SMITHFIELD CITY PLANNING COMMISSION MINUTES June 21, 2023

Smithfield City Staff Report

Smithfield City Staff Report

Lupine Village MPC Preliminary Plat

SITE PLAN

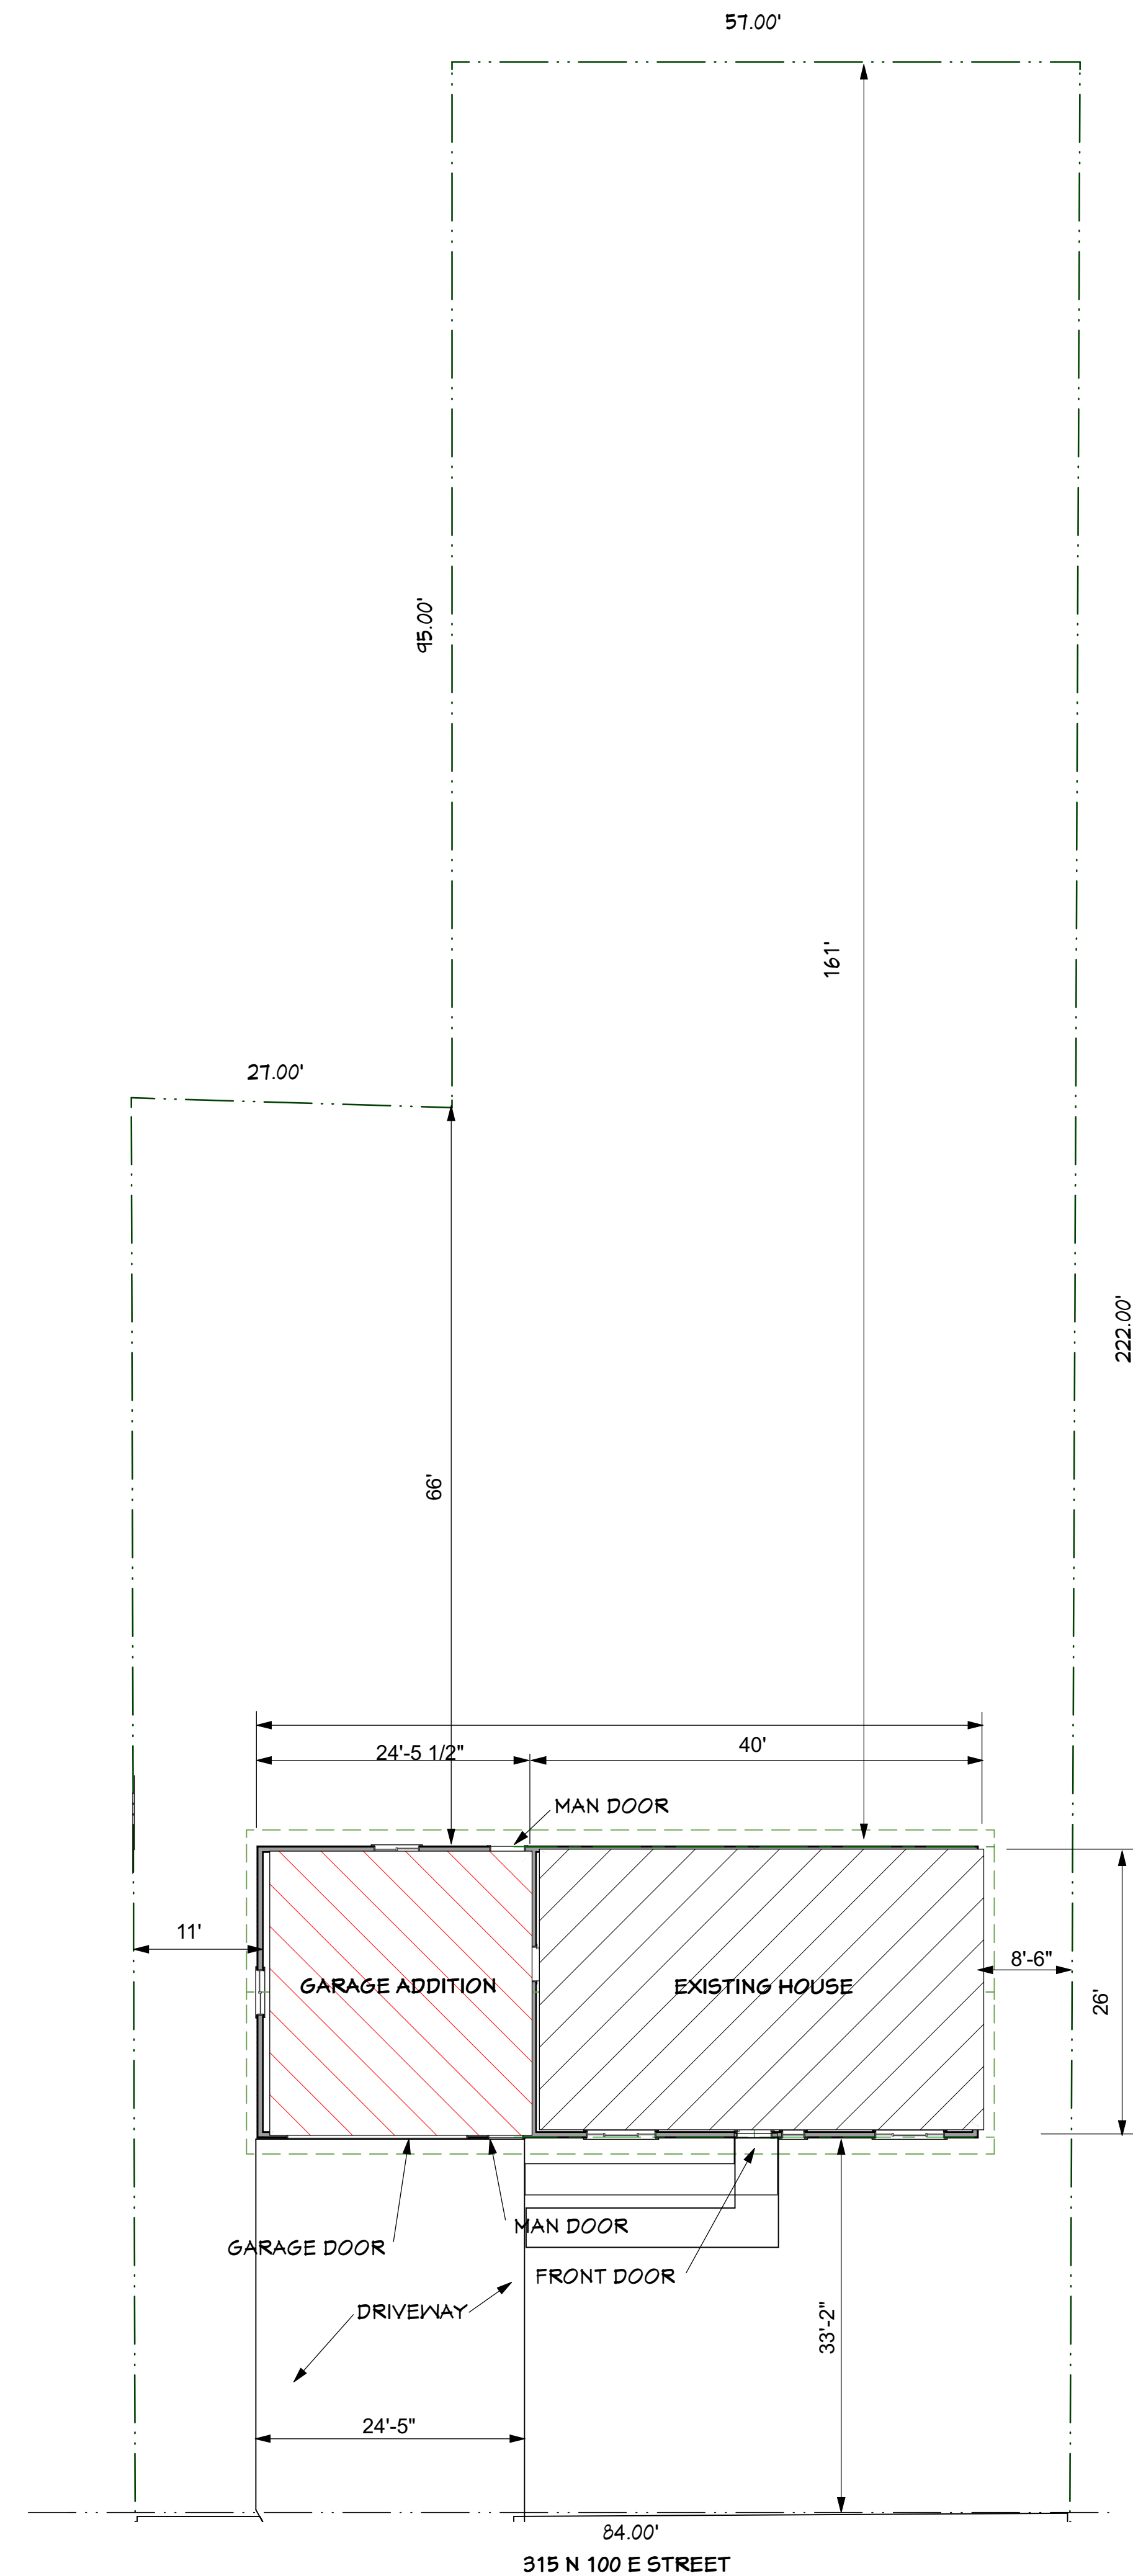
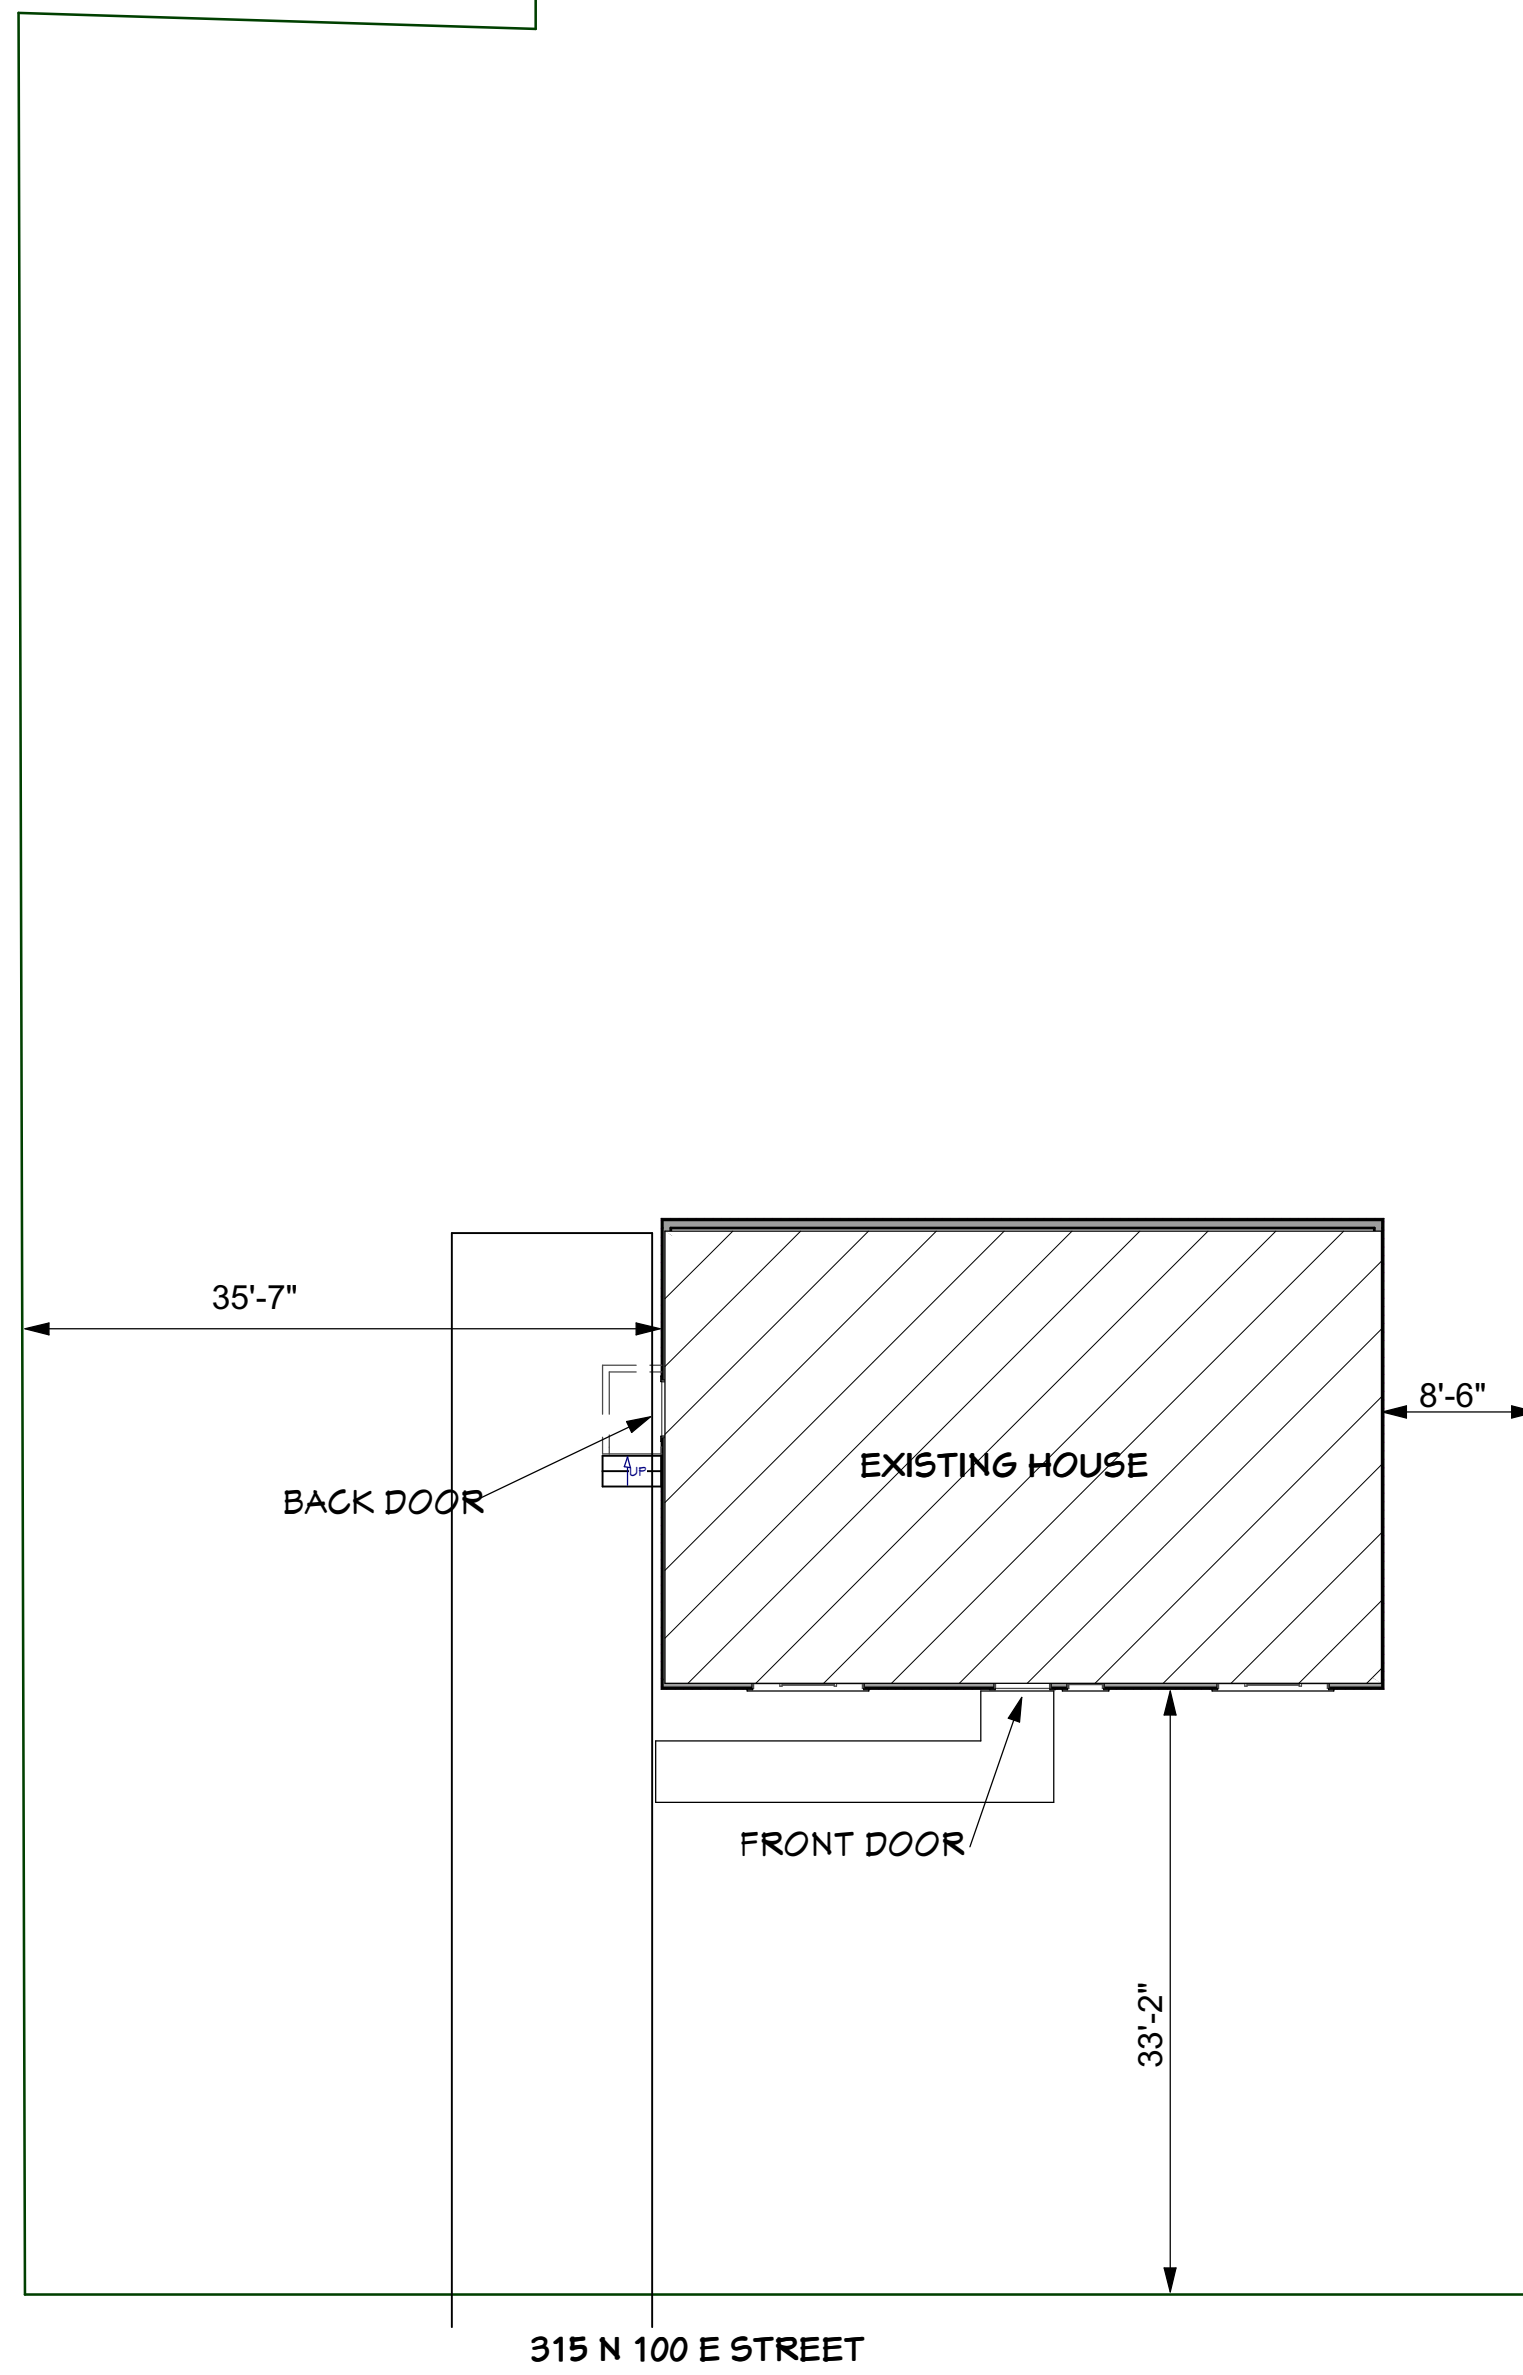
Cara and Grandon Brewer are requesting approval of a conditional use permit, for a home addition on their existing residence that is considered a non-conforming structure/lot. They would like to add a garage addition to the west of the house. The property and home are considered non-conforming due to the distance of the residence to the East property line. The new addition would not increase the height or outward appearance of the existing residence.

PRELIMINARY LANDSCAPING

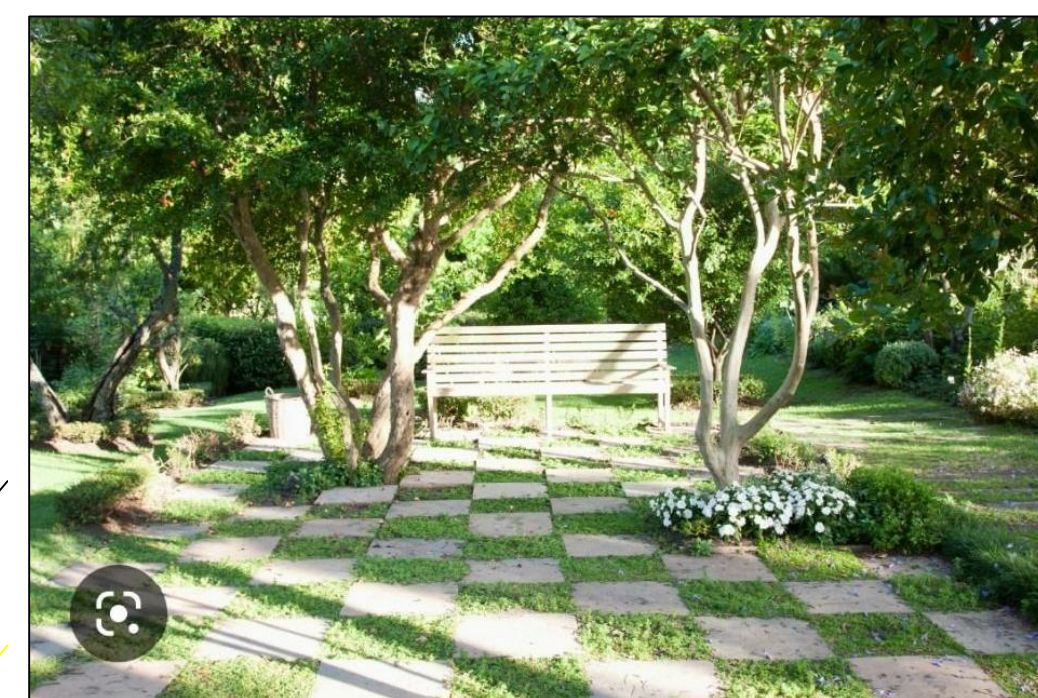
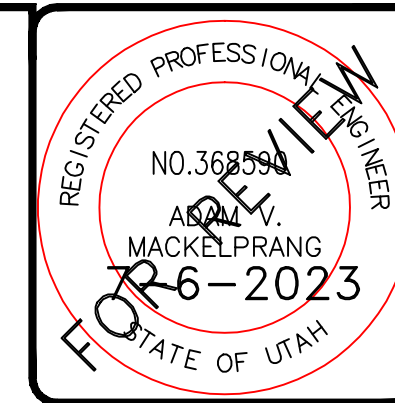
The STRC met with Tami agents for Jay Stocking on the Lupine Village on July 5, 2023, concerning a 129-unit MPC (Master Planned Community) subdivision located at; 520 North 400 West. (The Olsen property). The developer is proposing the development as an MPC zone with some density bonuses that the Commission and Council will need to examine and decide if they agree with the bonus requested. Also, the subdivision request will come before the Commission and the Council, and the preliminary will need to be (approved / denied) by the Commission and will need to be presented to the Council as a concept and rezone. The Council will not need to approve the preliminary, but they need to see the preliminary/concept plan as part of the rezone request for this proposed MPC zone. Also, the minutes should reflect any changes to the plan that the Council puts in the motion. The development agreement proposing the sewer HOA fees should be included. A note on the final when it is presented should explain that the HOA accesses fees for the Sewer lift station and its maintenance.

The developer will be constructing the main lines with the required 8in DI, however because there are a lot of users on the system and there is a potential for it to go even farther northward, So the main line on 400 West will be upsized to a 10in. The railroad tracks provide a temporary barrier for redundancy with waterlines to the East. The Parking lots for the multi-family will need to show how the fire truck is expected to access the lot with cars in the parking spots.

The proposed sanitary sewer collection system has a lift station that will empty connection into our existing gravity flow system. This connection will need to relay the existing pipe in 400 West. As part of the project, they will be “re-laying” the existing sewer line in 400 west that is not to standard slope.

Storm water does not have an existing city system in which to tie into. It will be required to show that the capacity of water retention pond for the whole development will handle the volume of a 100-year storm event. That is why the pond at the NW end is so large.

Street alignment has been shown on the Preliminary plan, the streets that are of a radius less than our Construction Standards will need to be flattened and the intersections will need to meet at angle of 5 degrees or less.

The trail at approximately 529 north and 510 west should be shown as the care of the HOA. The existing road on 400 west will need to be a good road to half plus ten feet. The irrigation company is included on the STRC invitation, and it is part of Smithfield Irrigation. A traffic Study and a soils report will be required of the developer to supply the city before the Council sees this as a rezone.
